**CORRESPONDENCE COVER SHEET  
WASTE PERMITS DIVISION  
TEXAS COMMISSION ON ENVIRONMENTAL QUALITY**

Date: April 25, 2019  
 Facility Name: City of Kingsville Landfill  
 Permit or Registration No.: MSW 235-C

Re: City of Kingsville Landfill – Kleberg County  
Municipal Solid Waste (MSW) - Permit No. 235C  
Permit Amendment Application – Notice of Deficiency  
Tracking No. 23301130, 23458984, and 24040819; RN102334570/CN600674246

On behalf of the City of Kingsville and in response to the Texas Commission on Environmental Quality's (TCEQ) March 27, 2019 Notice of Deficiency (NOD) letter, we hereby submit the enclosed response regarding the Permit Amendment Application for the above referenced MSW facility.

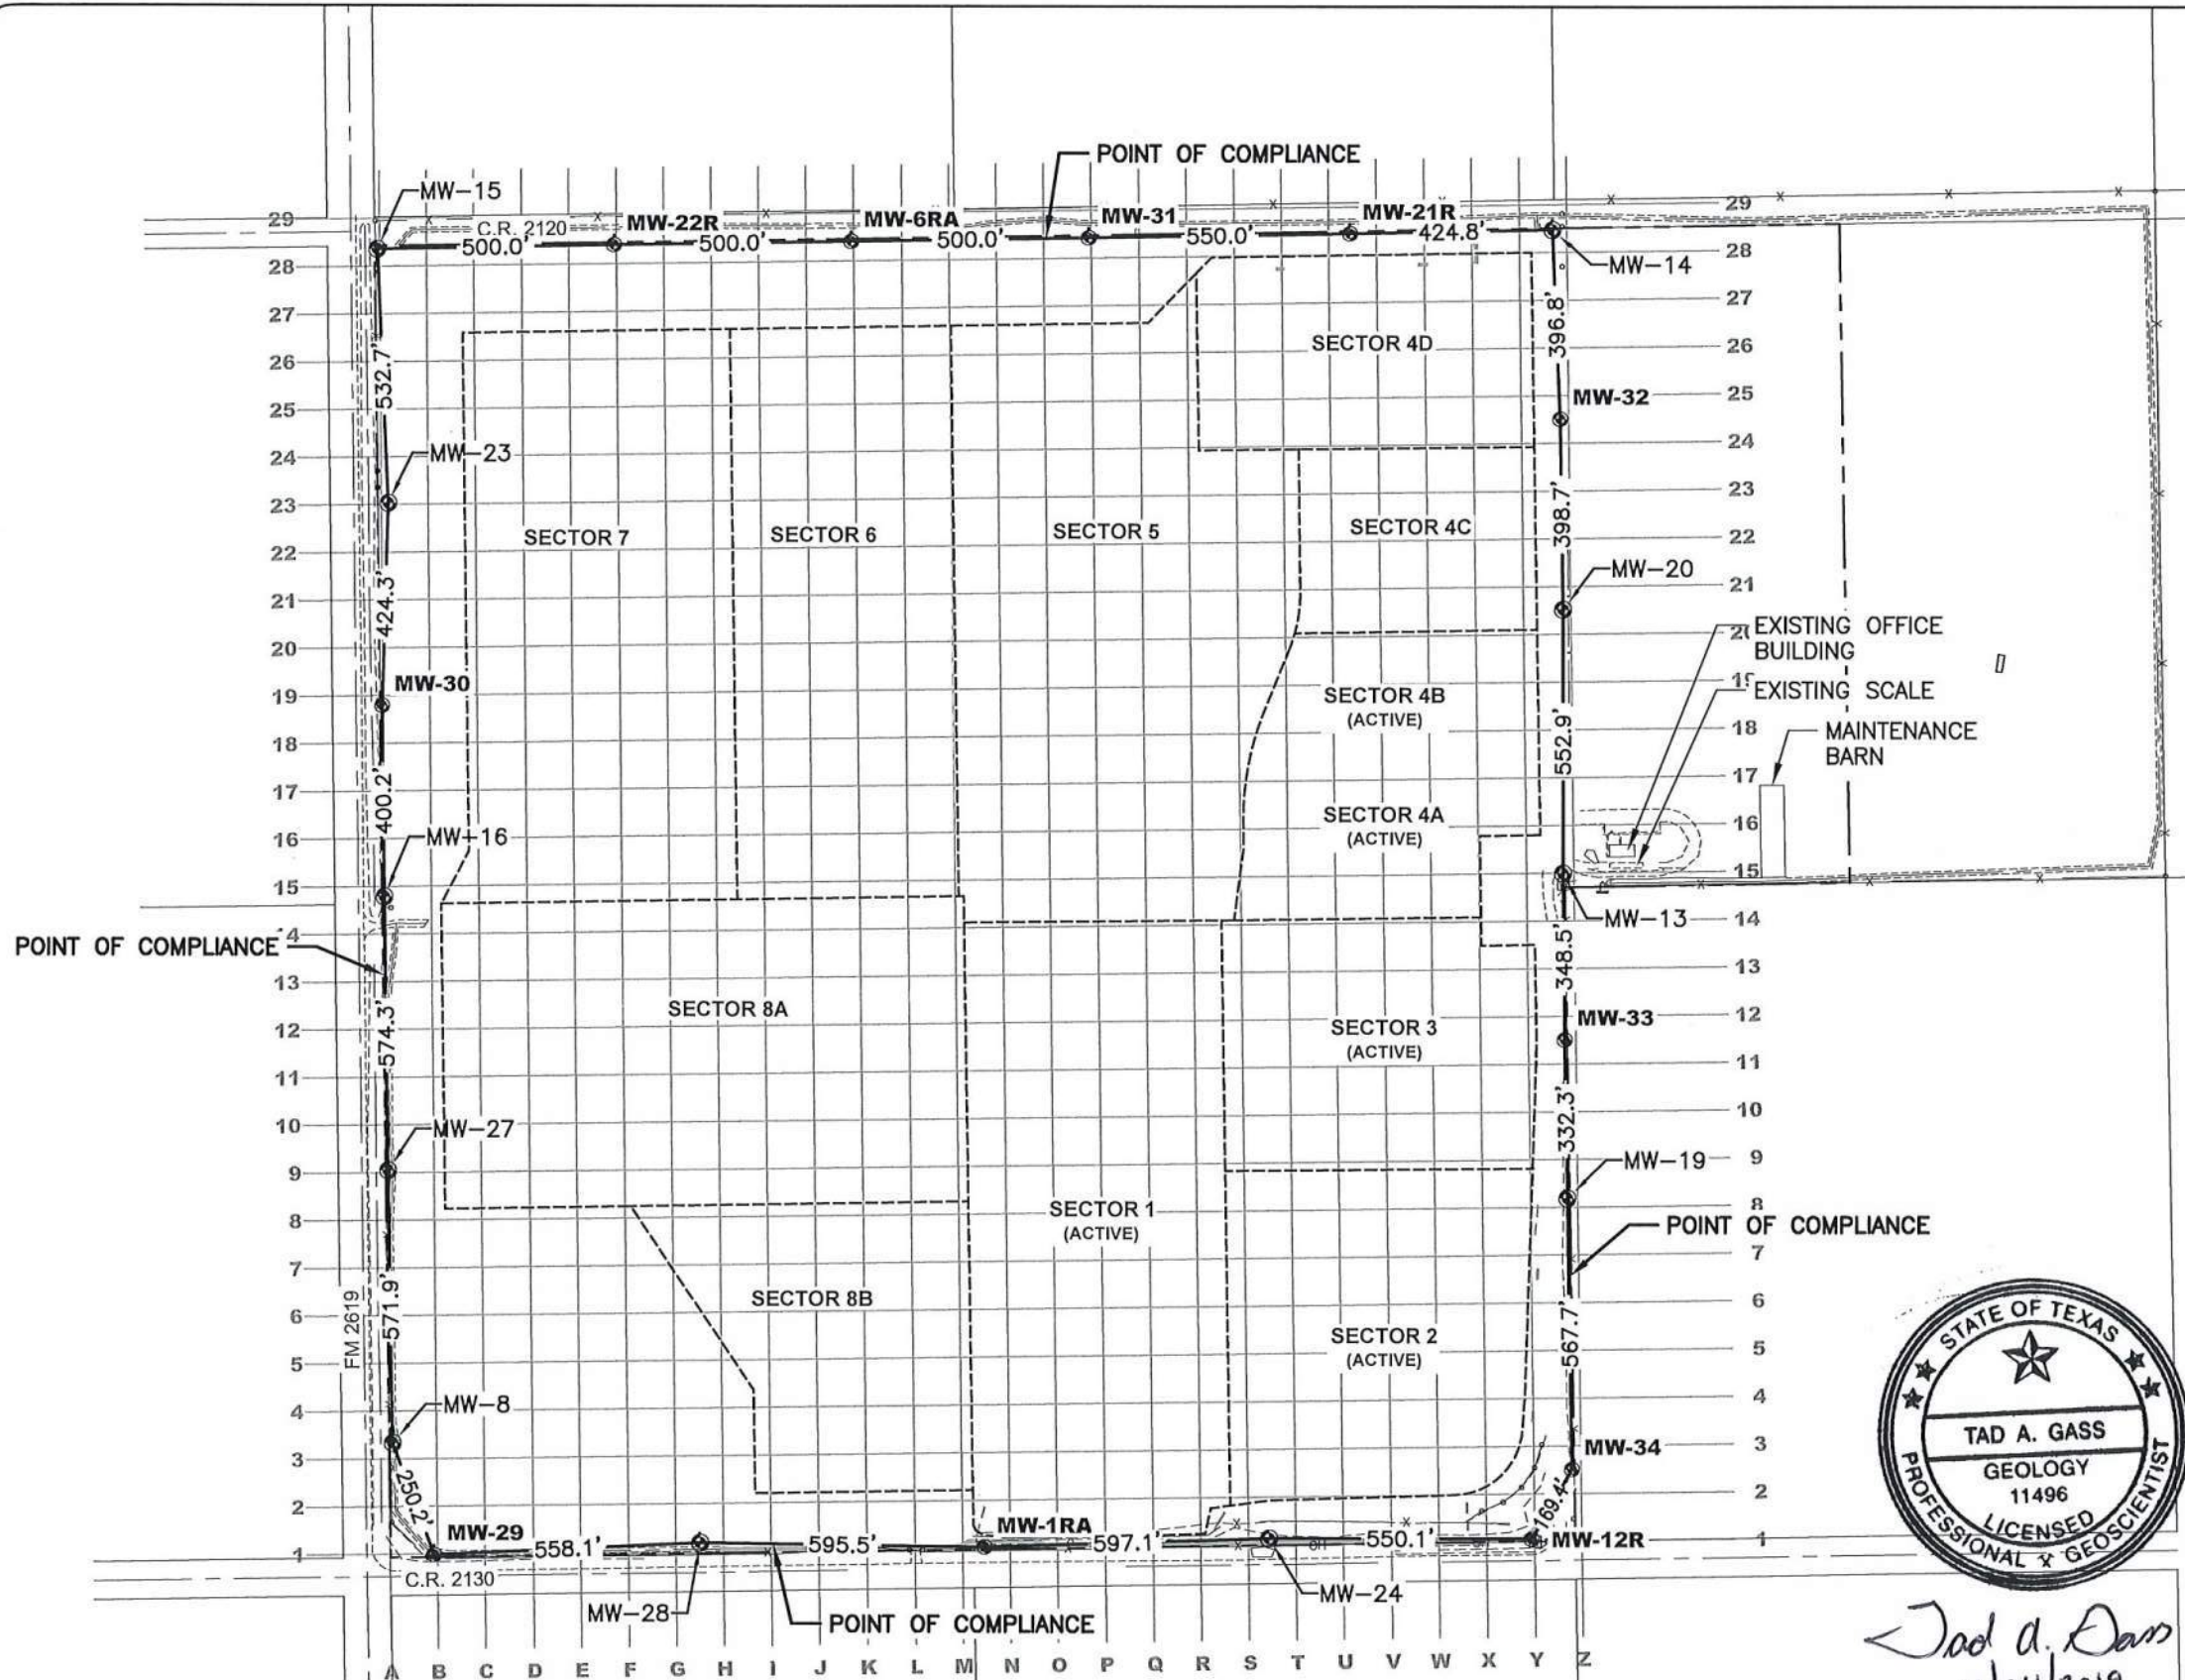
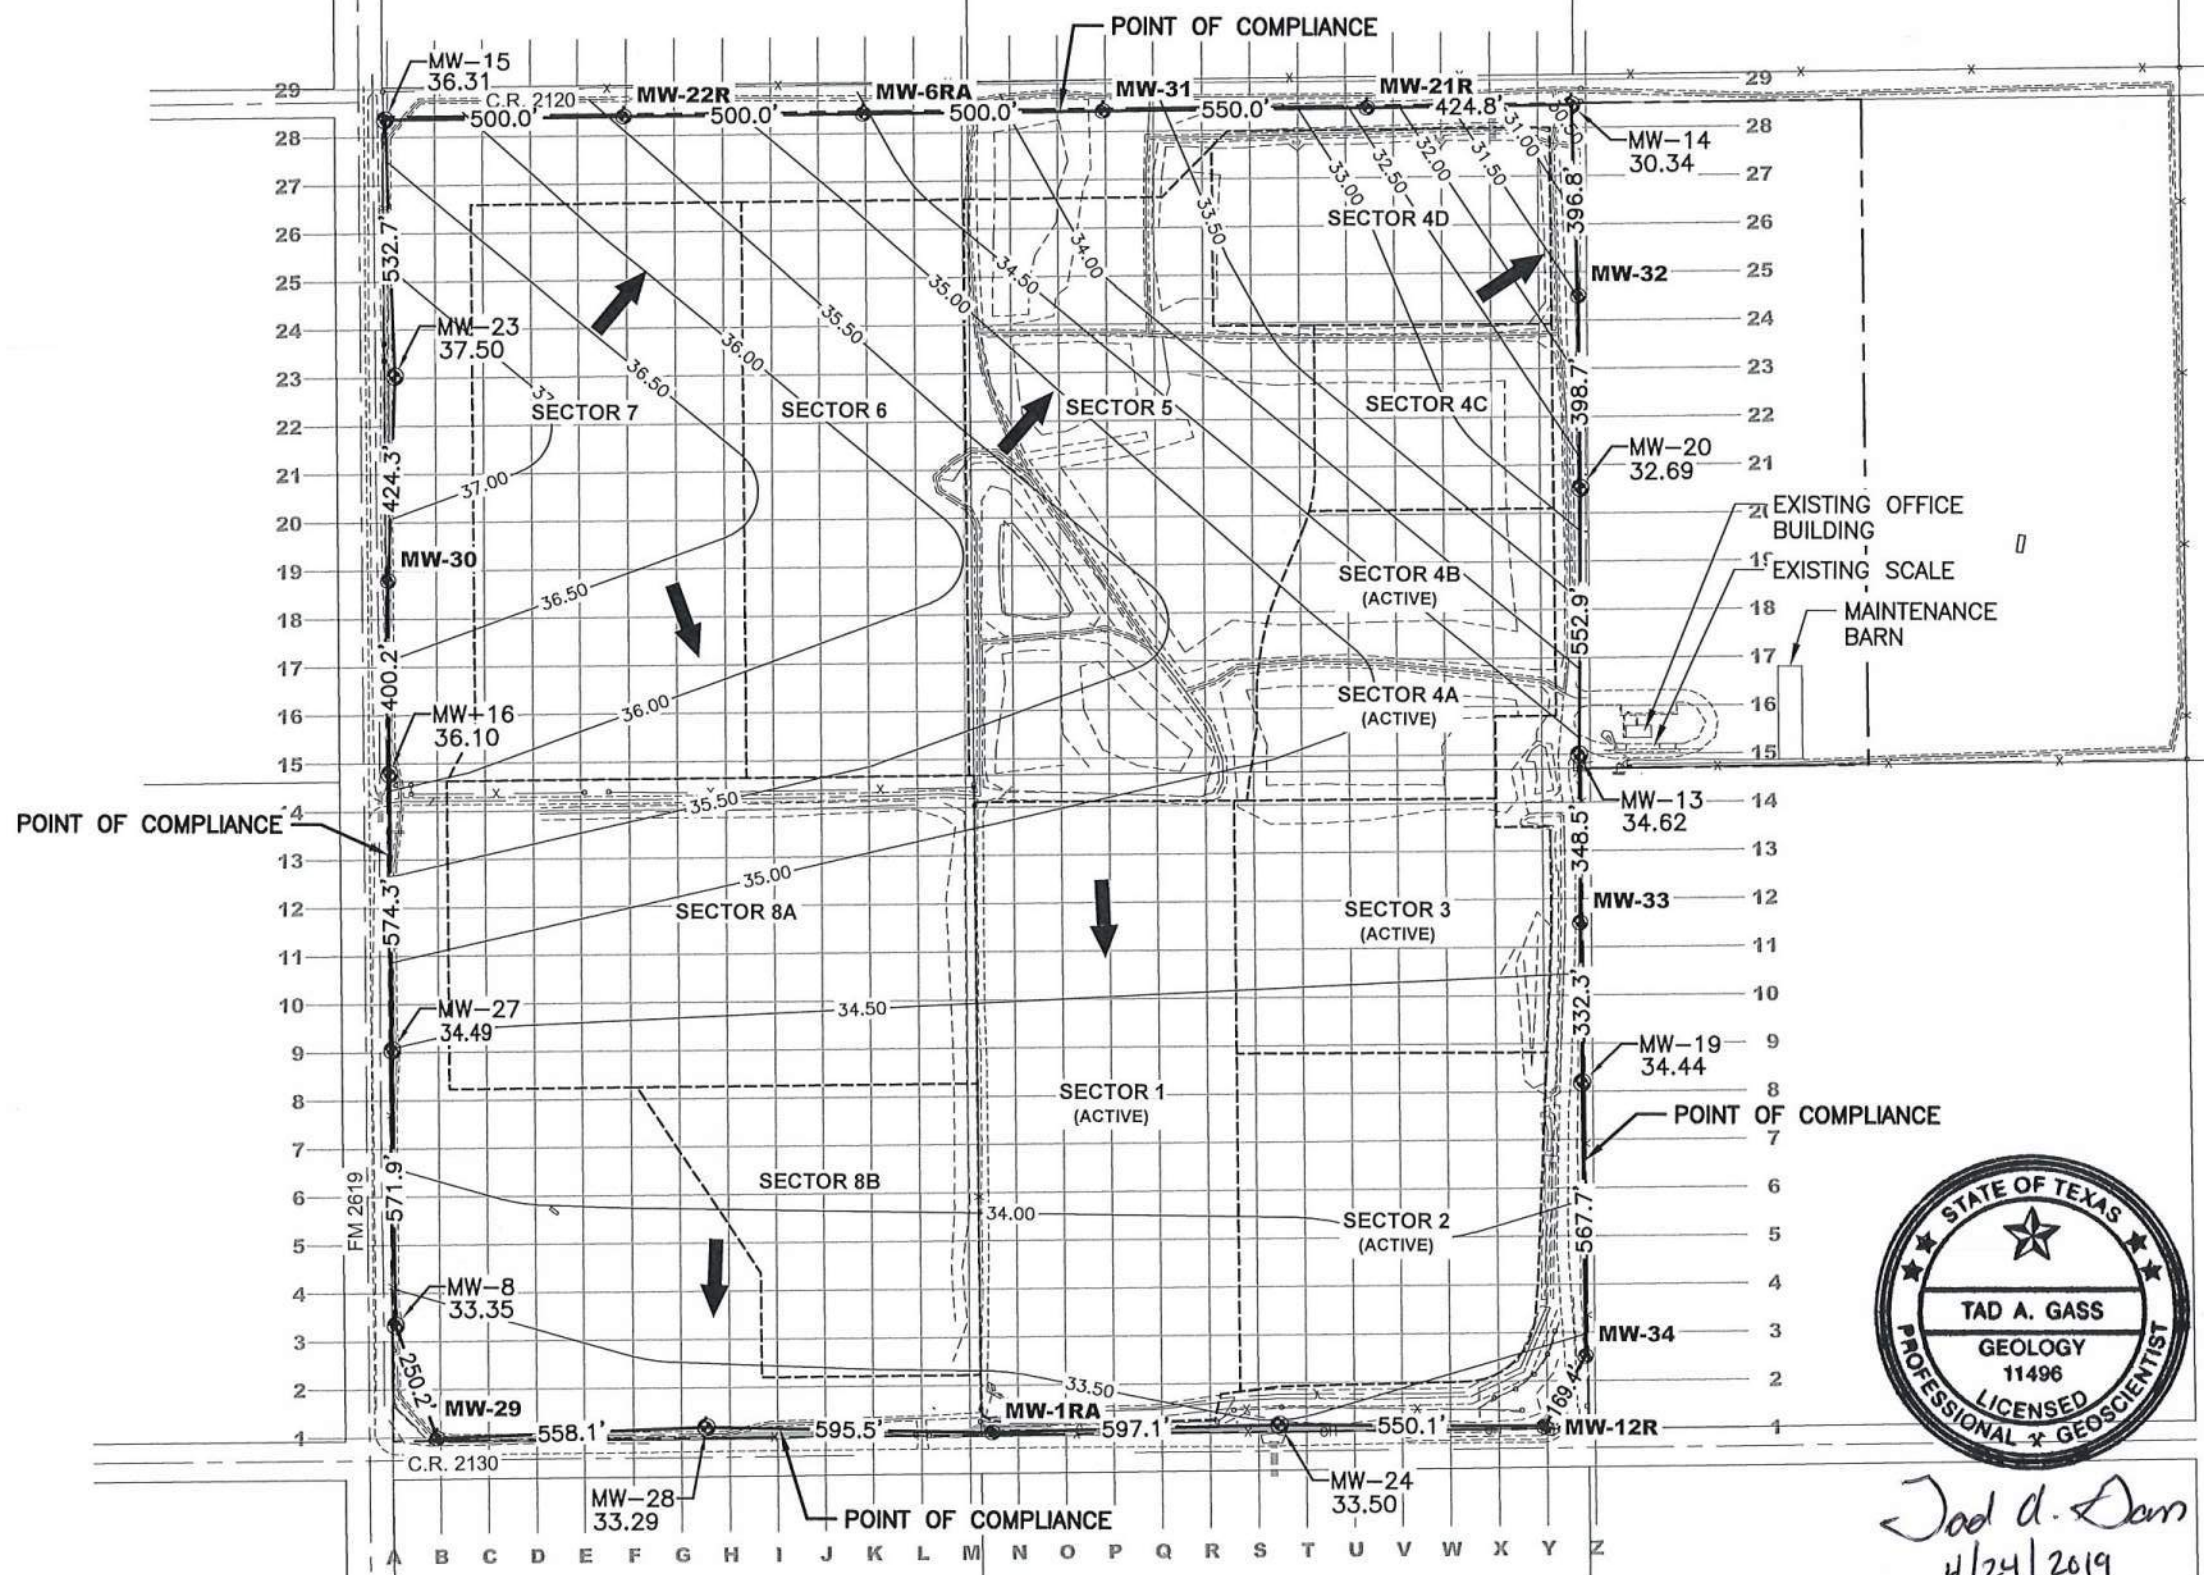
T36	511	Part III	330.63(f)(1)	Att 11, App A, Item 1	Ambiguous	Provide a distinct line for the point of compliance line on Figures III.11-A-1A and 1B.	A distinct line for the point of compliance line on Figures III.11-A-1A and 1B has been provided.
T37	558	Part III	330.403(a)	Att 11, App A, Item 1	Incomplete	Revise Figure III.11-A-1B to include the date of the groundwater measurements, and the measured groundwater elevation at each well.	Figure III.11-A-1B has been revised to include the date of the groundwater measurements, and the measured groundwater elevation at each existing well.
T38	559	Part III	330.403(a)(1)	Att 11, Sec 3.1, p. 2; Sec. 1.2, p. 1	Ambiguous	Provide a table detailing which wells "shall be considered upgradient wells until further development of waste sectors occur" and at what stage of landfill development they will become point of compliance wells.	A table detailing which wells "shall be considered upgradient wells until further development of waste sectors occur" and at what stage of landfill development they will become point of compliance wells has been included as Part III, Attachment 11, Appendix A, Table 3, pg.1.

**CITY OF KINGSVILLE LANDFILL**  
**ATTACHMENT 5**  
**FIGURE IV.5-1**  
**LIQUID WASTE SOLIDIFICATION AREA**  
**LAYOUT PLAN**

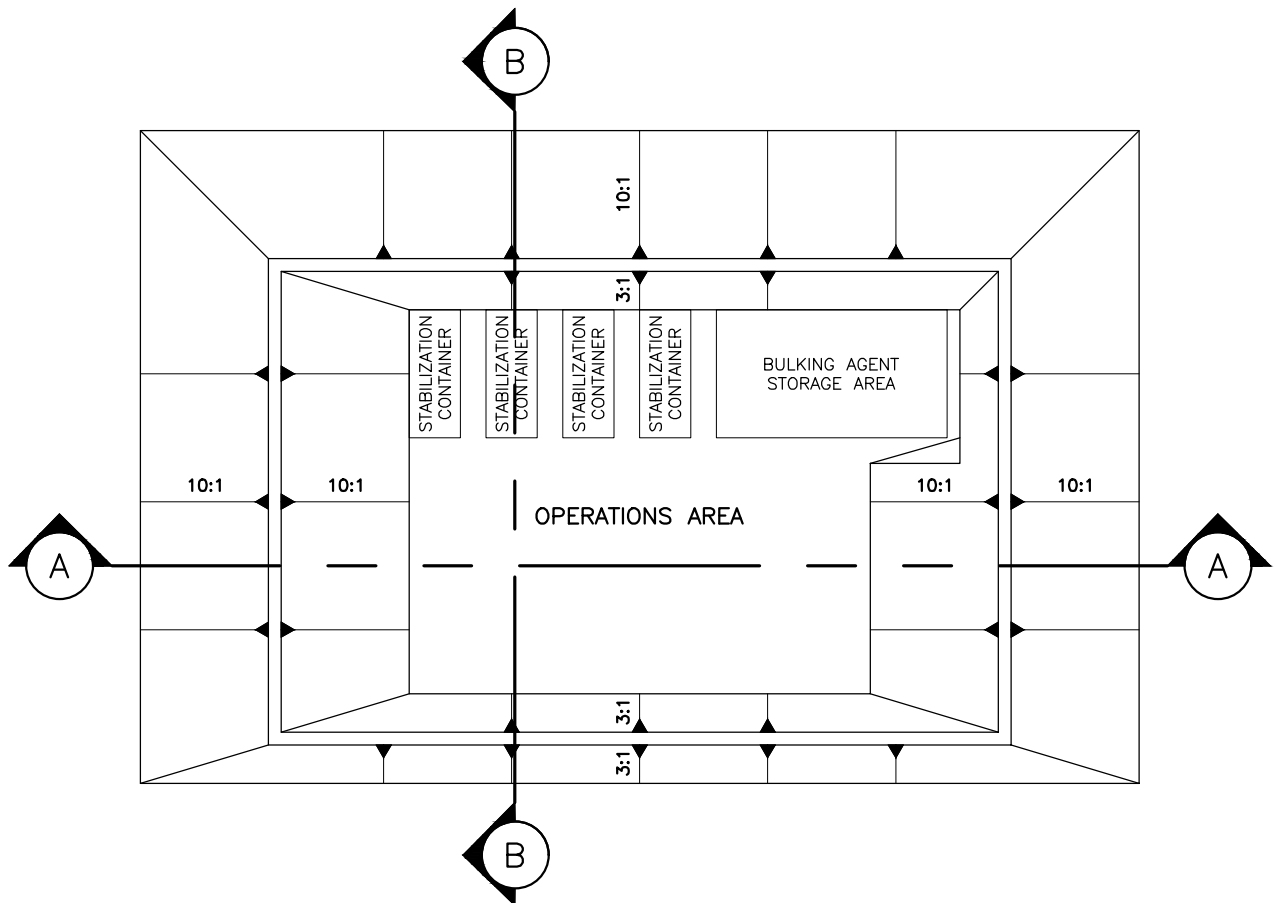
T7	277	Part III	330.63(b)(2)(D)	Vol 1, Sec 3.2.3, pg- 6	Inconsistent	Clarify if a liquid waste solidification facility is being proposed, and revise (also Part II, Sec 2, pg. 3-4, and Part IV, Att.5) Revise Figure III.1-2 to depict the solidification facility.	A liquid waste solidification area is proposed. Part II, Sec 2, pg. 3-4 has been revised. Part IV, Att.5 has been revised to include additional information regarding the design and construction of the liquid waste solidification area including Figure IV.5-1 Liquid Waste Solidification Area Construction Details. The Liquid Waste Solidification Area will be installed within an area that is operationally feasible and will periodically be relocated because of general sequence of filling operations. Due to the liquid waste solidification area being relocated periodically Figure III.1-2 was not revised to depict a permanent location. However Figure IV.5-1 was included in Part IV, Attachment 5 to depict the liquid waste solidification area layout and construction details.
